# **Waverley Council Chambers Upgrade**

49a Bondi Junction Road, Bondi Junction

Preliminary BCA and Certification Assessment 2020/3168 R1.3

Image taken from ePlanning Portal.

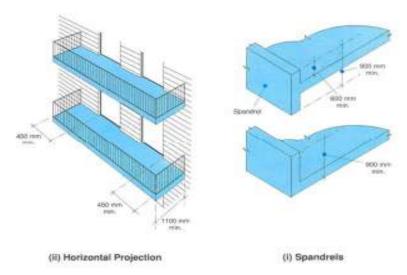
The southern external wall is located within 3m of the boundary. The wall is required to have an FRL not less than 120/120/120 and openings protected in accordance with Clause C3.4. It has been proposed to investigate whether the wall can be addressed via a Performance Solution by the Fire Safety Engineer.

The building is sited over 2 separate lots. In this situation it is assessed as a united building and the boundary that passes through the building is not considered a fire source feature.
